RAPID UPDATE

Rapid Update 623 Grecale – ITM Software Update

DATE: APRIL 28 2023

F14 10 KL30 ASU ITM

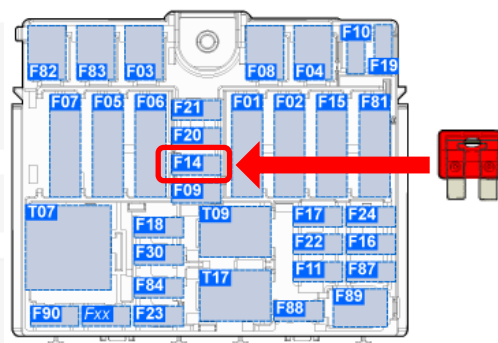
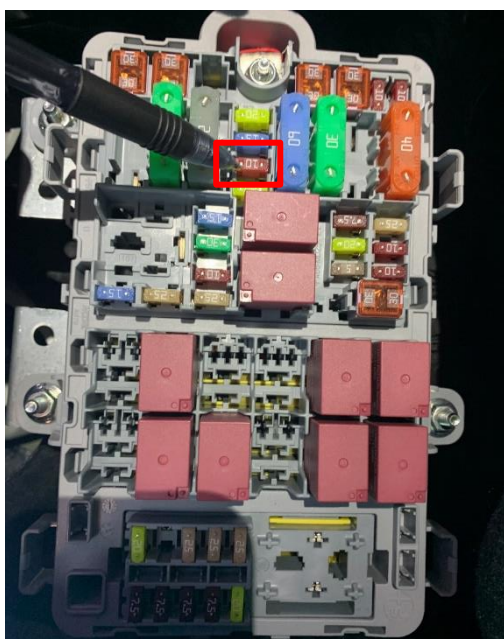
1. Access the Rear Distribution Unit (RDU) and re-install the **F14 10A** fuse that was removed previously per Rapid Update 599, indicated in the pictures below:

- Write the new **"Vehicle Configuration"** via BCM procedures using the MD-EVO.

- Clear any leftover DTCs.
- Continue with the SW Update below:
